EFDC Householder & Other Minor Applications Check List

Application Details & Constraints					
Case Ref:	EPF/0254/25	PL No:	016951		
Site Address:	12, Barnaby Way, Chigwell, IG7 6NZ				
Proposal:	Proposed two storey rear extension, single storey side extension and first floor side build over.				
Green Belt	Yes ☐	No ☒	TPO	Yes ☐	No ☒
Conservation Area	Yes ☐	No ☒	Heritage Asset (Listed)	Yes ☐	No ☒
Flood Zone	Yes ☐	No ☒	Enforcement	Yes ☐	No ☒
Representations					
Town/Parish Council Comments, if any: Chigwell Parish Council: <i>'The Parish OBJECTS on the grounds it considers the proposal to be bulky and the front dormers to be not in keeping with the neighbouring properties. If, however, all relevant Officers deem this application acceptable, whether with amendments or not, then the council is willing to waive this objection'</i>					
Objection ☒	No Objection ☐	Comment ☒	None Received ☐		
Neighbour Responses, if any:		None			
EFDC Environmental Protection and Land Drainage		No objection or conditions to request.

Project:	BATEMAN 12 Barnaby Way, Chigwell, IG7 6NZ	Boundary Demolition Ext Walls Prop Walls FFL Height
Drg Title:	Proposed Plans & Elevations	
Scale:	1:50 / 100 @ A1	
Drawn By:	KD	Date: 01/2025
Drg No:	(25) 01/01 PL01	Rev:

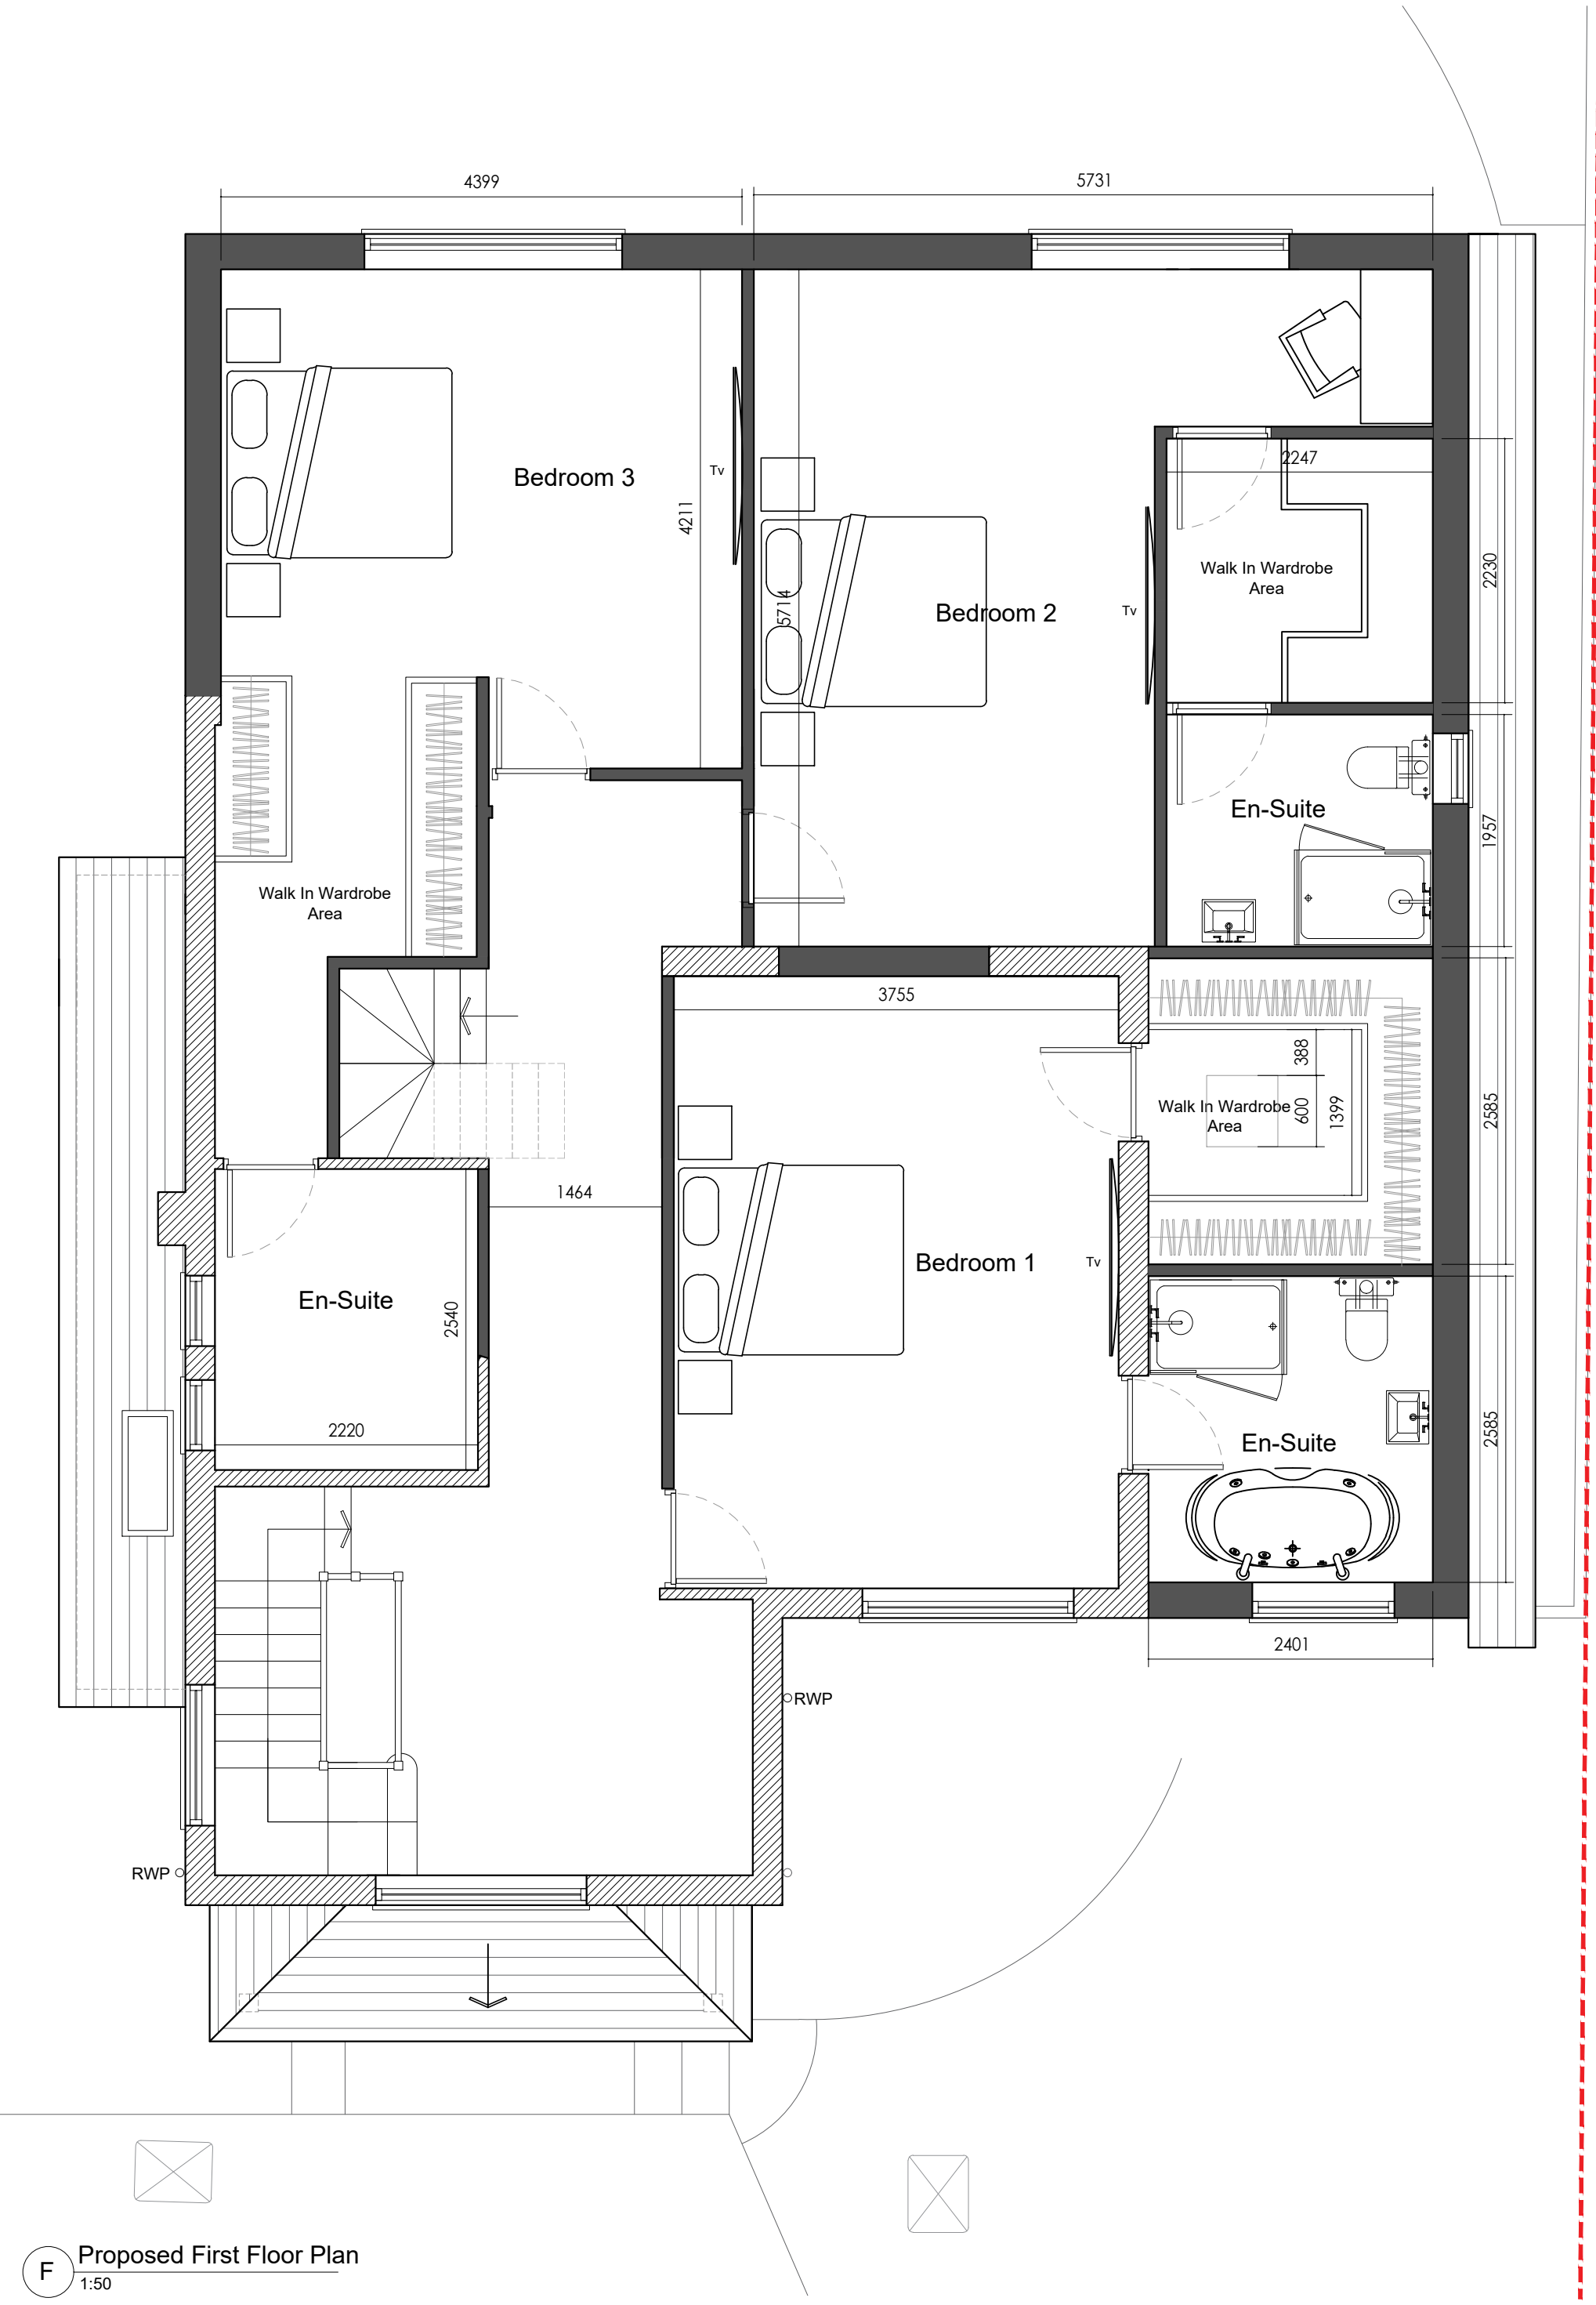
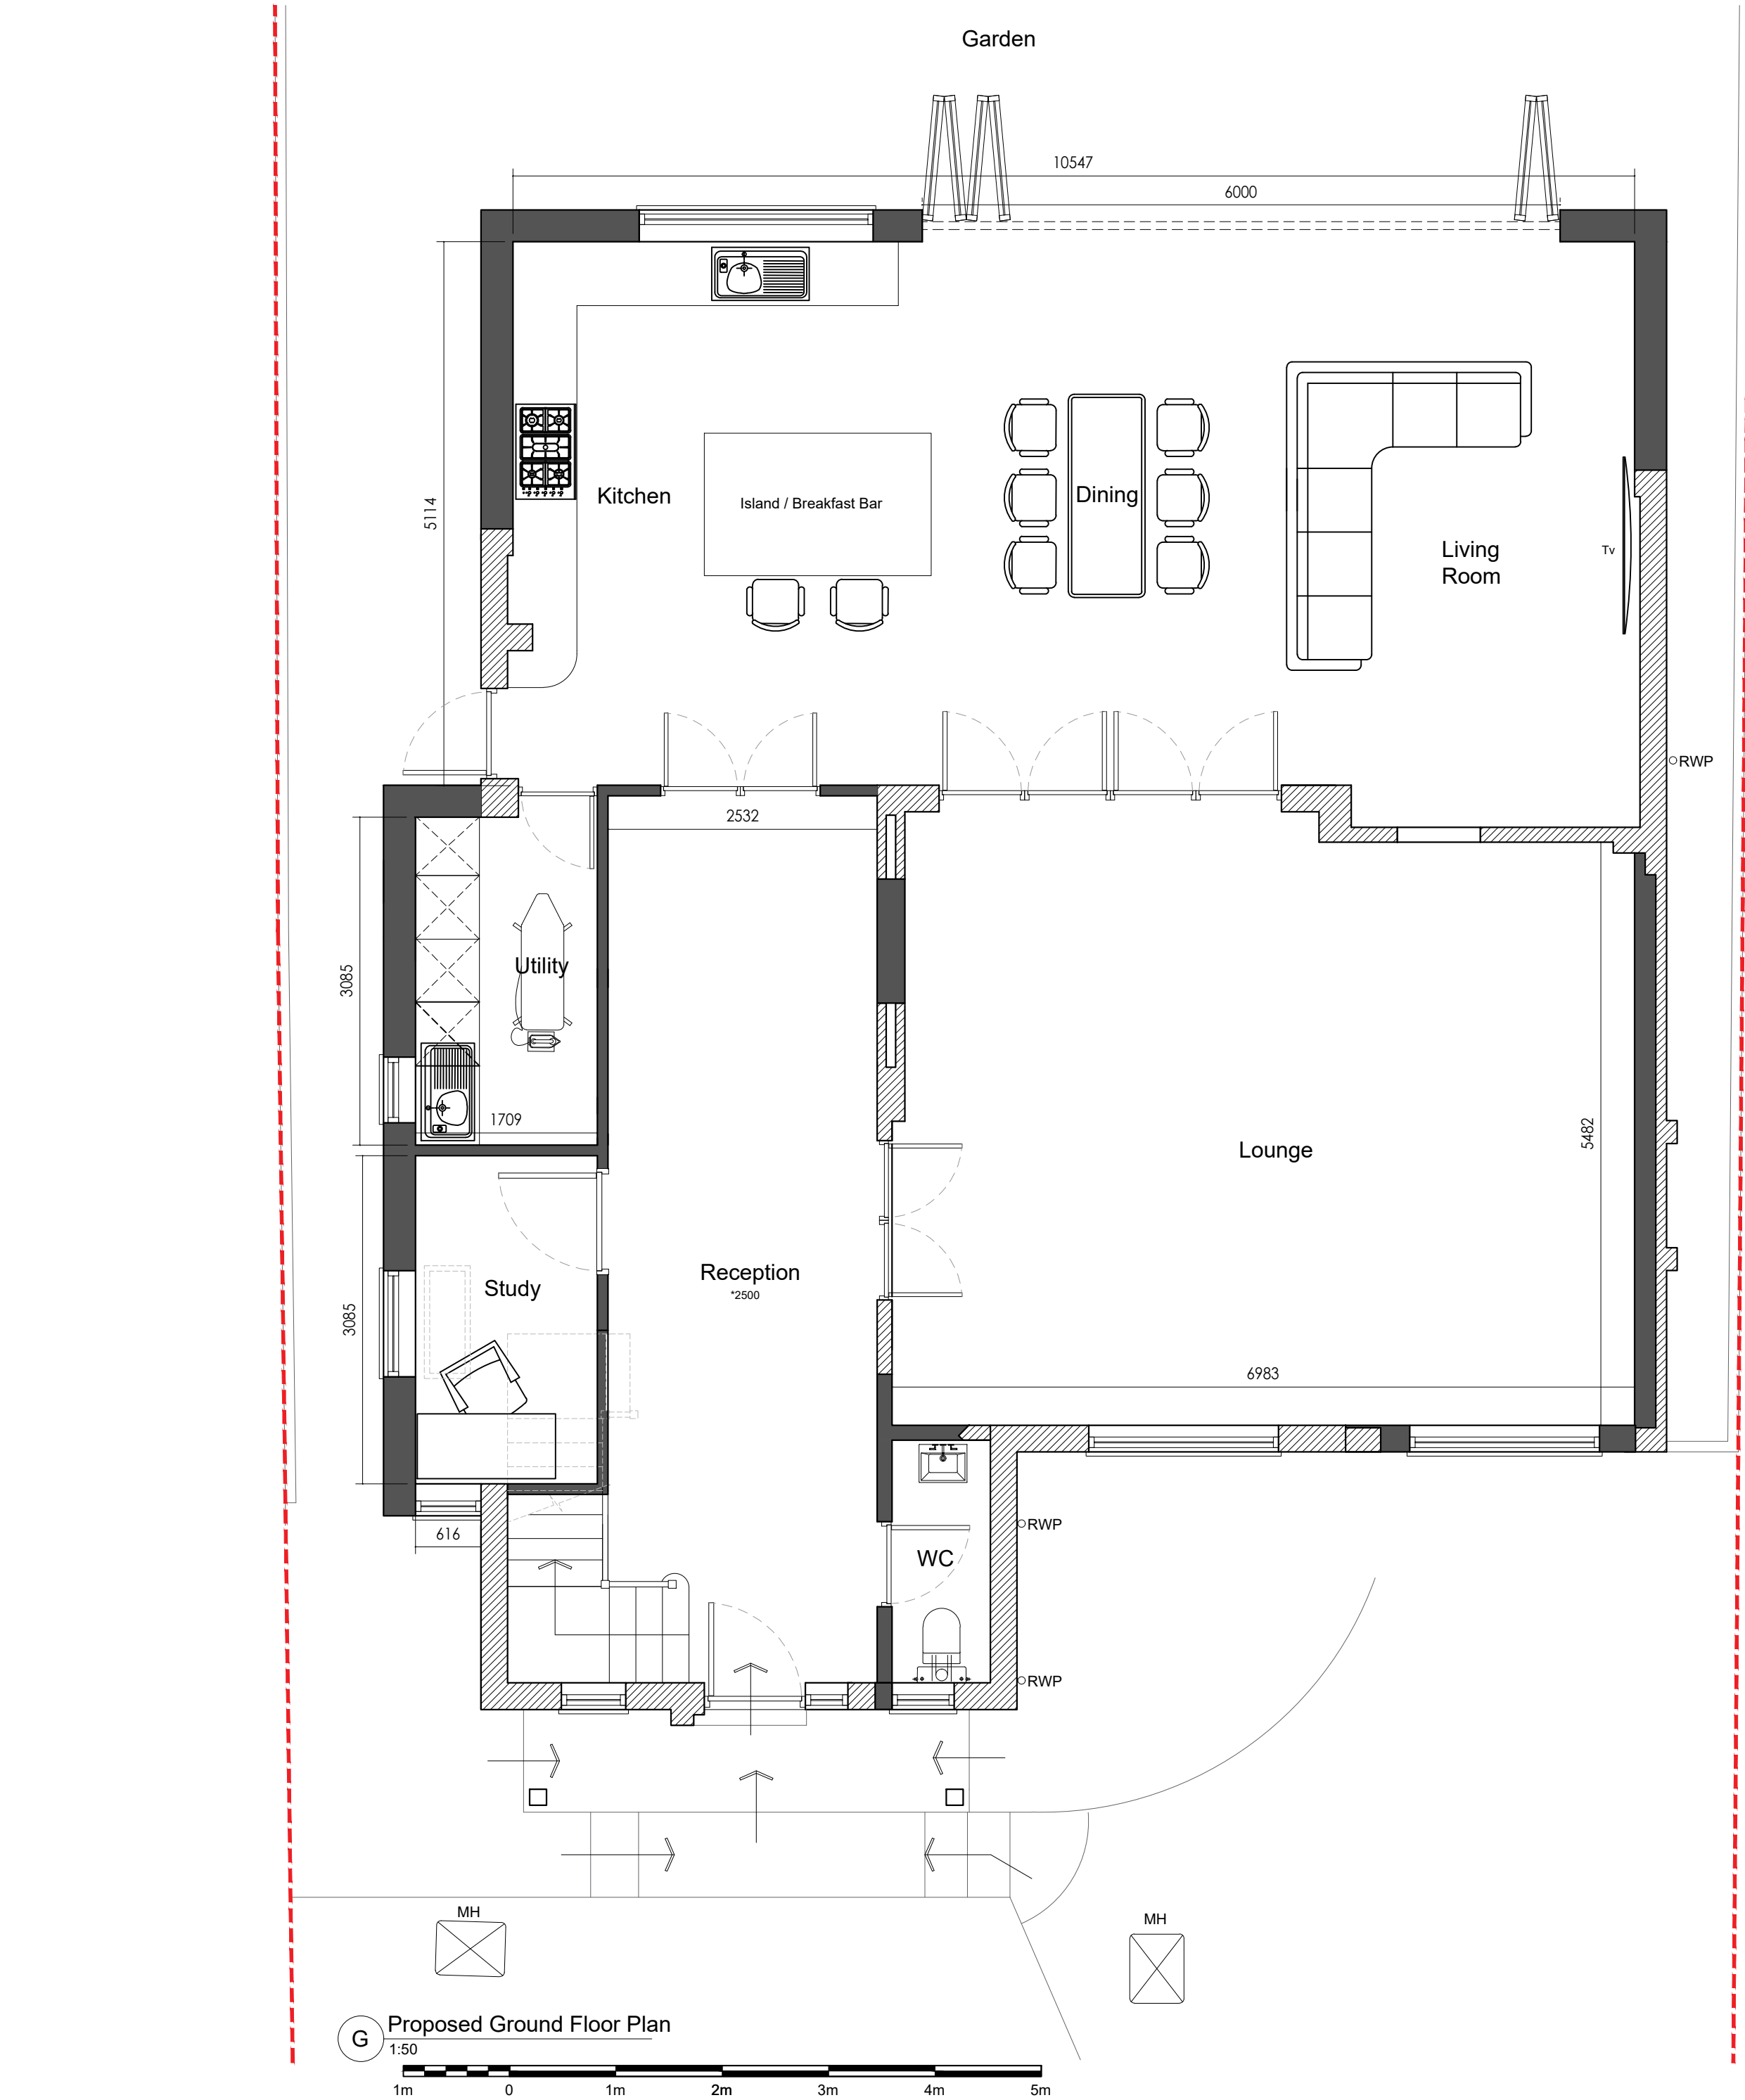
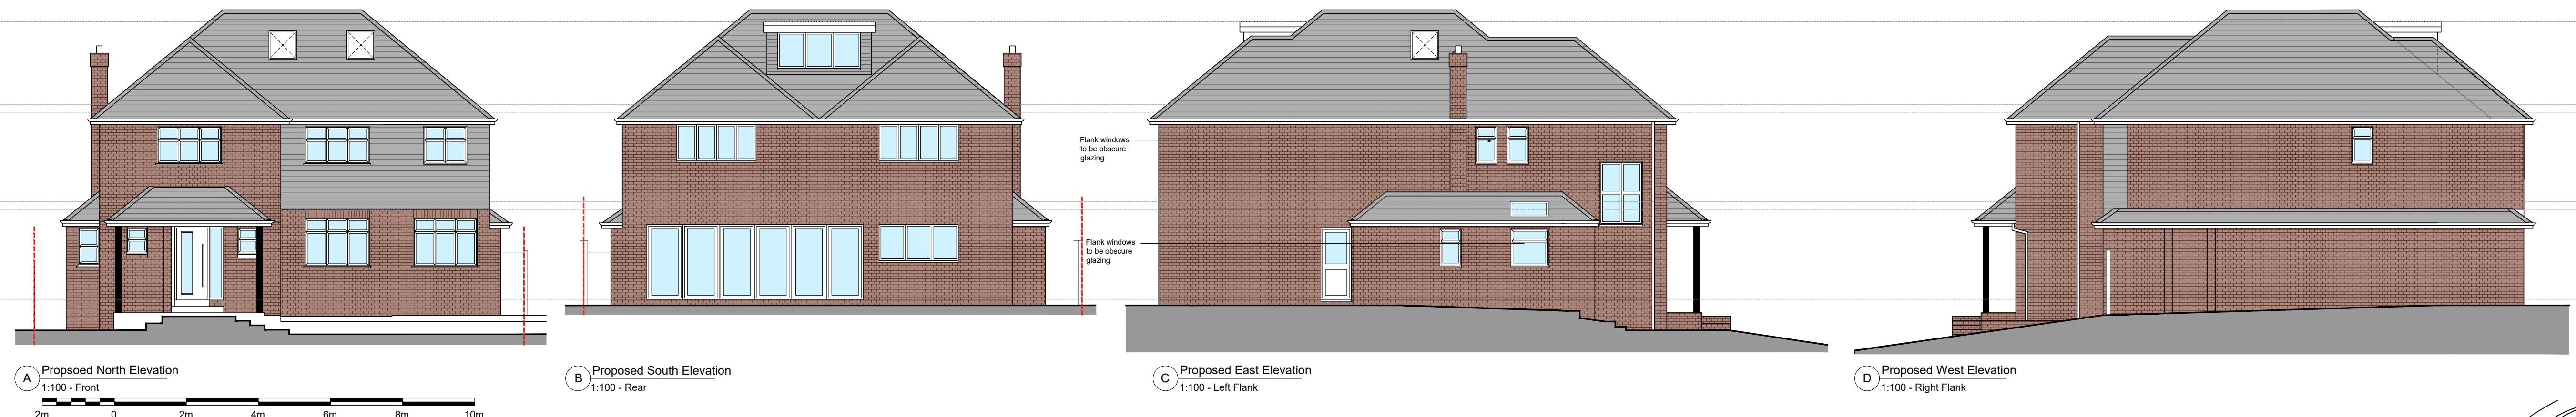
Planning Considerations		
Character and Appearance: The application site is a two-storey detached dwellinghouse in a built-up urban area in Chigwell. Site topography presents differing land levels in all directions. It is sited on an elevated position alongside similar dwellings in the street. The street contains dwellings of individually distinctive architectural styles. The proposal enlarges the ground floor rear extension by 3m adding to a previous extension and aligns the rear first-floor flush with the ground floor. A similar development exists adjacent at no.14. The main issue is of the extended height of the dwelling on an already elevated position. The proposed roof form is extended by 0.5m higher to accommodate the loft conversion and forms a crown roof in a street with predominately unaltered hipped roofs. This would be visually apparent within the streetscene. Whilst the additional height is gained within the central main roof only, this would have a notable impact within the streetscene and together with ground level differences. The proposal is considered to result in harm due to its overall size to the existing character and appearance of the area.

The proposal would not extend beyond the building line of no.14, it does project further than its neighbour at no.10. Sufficient space is retained to the shared boundary however, given the rear configuration of no.10, and the curvature of the road, and in the absence of any set in, the proposed massing would result in a bulky overbearing form of development.

The proposal does not demonstrate impact to light in the plans through the BRE 45-degree rule. The proposed rear extension is likely to affect light to habitable rooms on both ground and first floors of the neighbour at no.10.

Officer Recommendation:	Approve	☐	Refuse	☒
--------------------------------	----------------	--------------------------	---------------	-------------------------------------
